Babcock & Wilcox

Docket No. 71-6400

Reference is made to your letter dated February 29, 1980 and our subsequent response letter dated April 29, 1980. Pennsylvania Operations (PA Ops) respectfully requests amendment of Certificate of Compliance No. 6400 for the Model 6400 ("Supertiger") shipping container as presented herein.

NINE DOOR GASKET

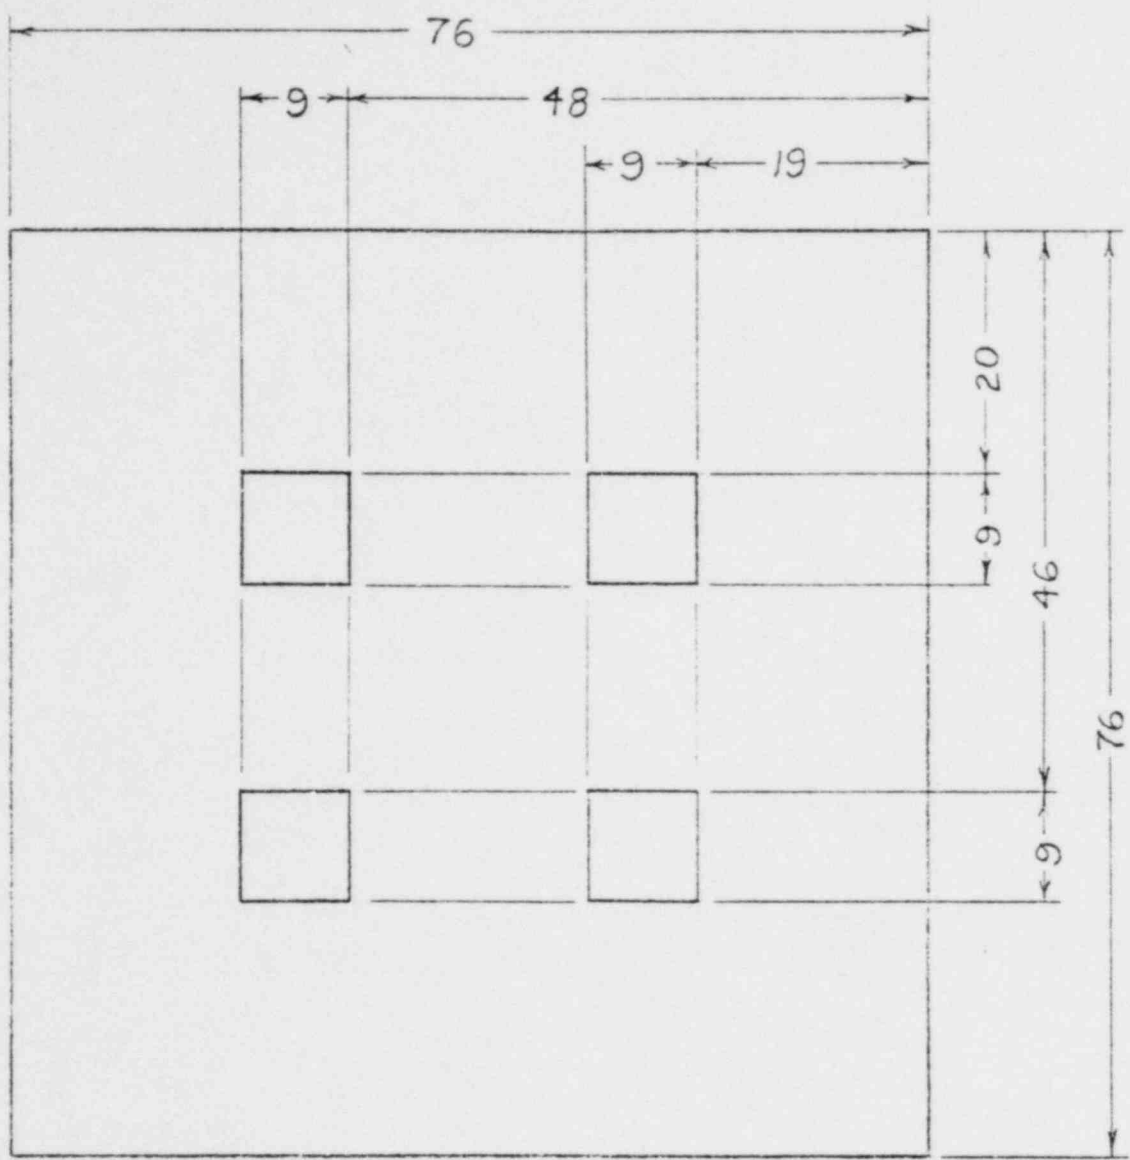
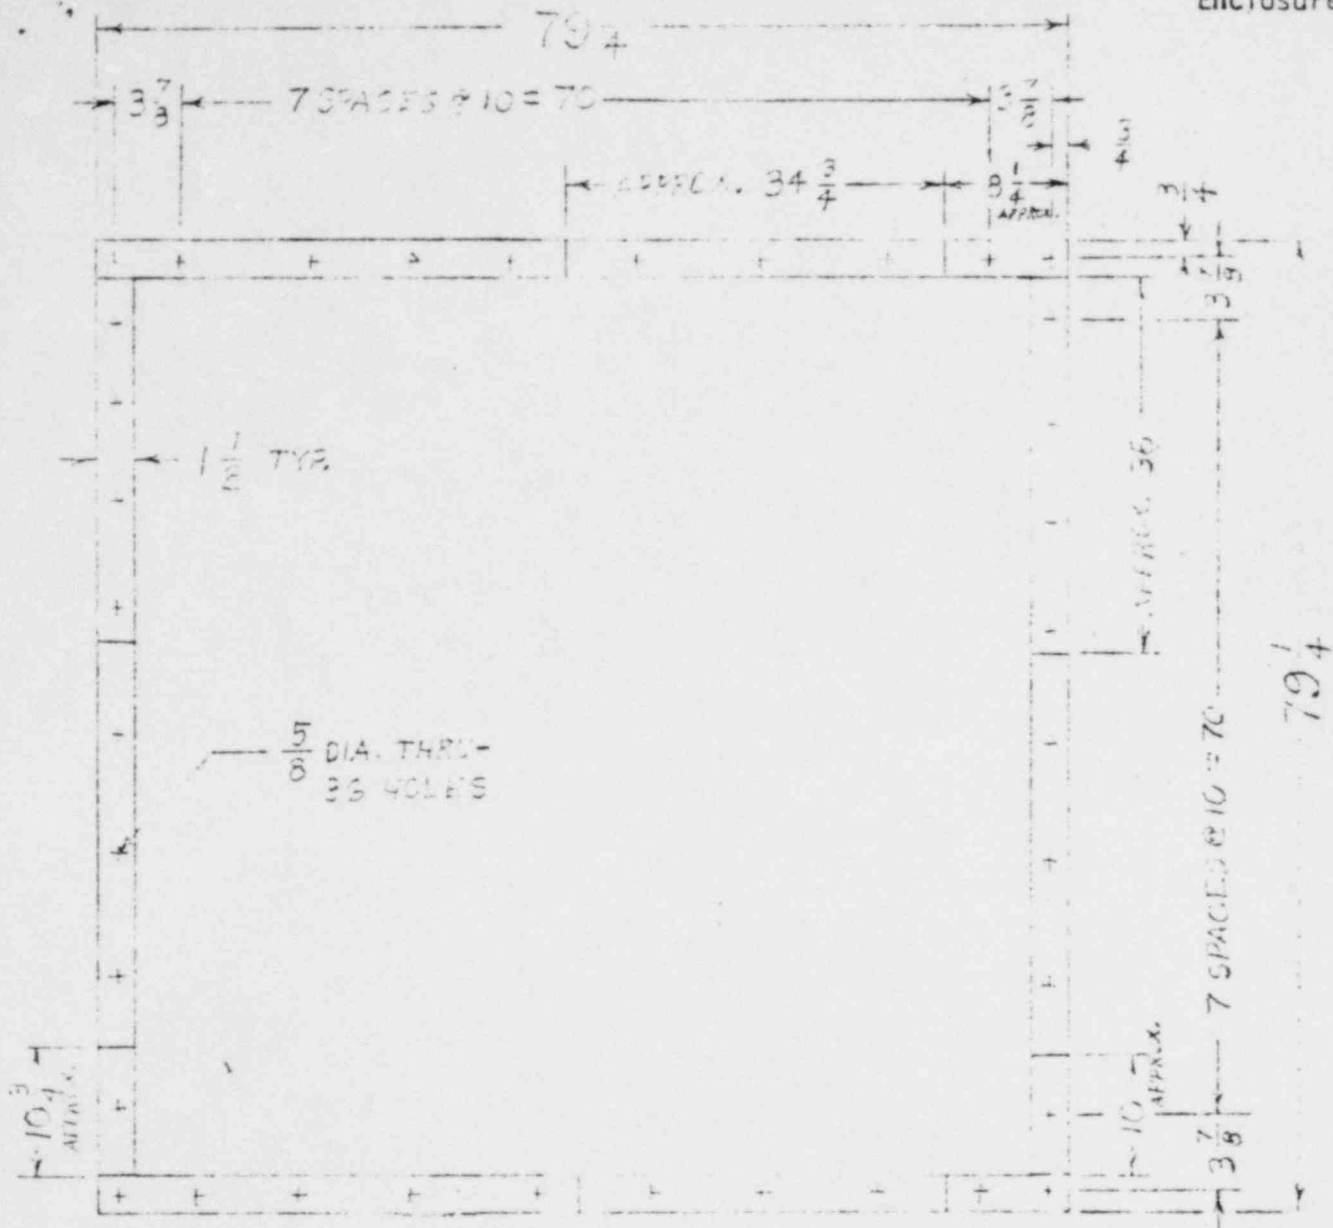
2. A detailed sketch of the seal for the inner cavity door is provided as Enclosure No. 2 to this letter.
3. On June 3, 1980, PA Ops' Quality Assurance inspected our Model 6400 shipping container for the five (5) conditions described in our above-mentioned response letter dated April 29, 1980. The inspection results are as follows:
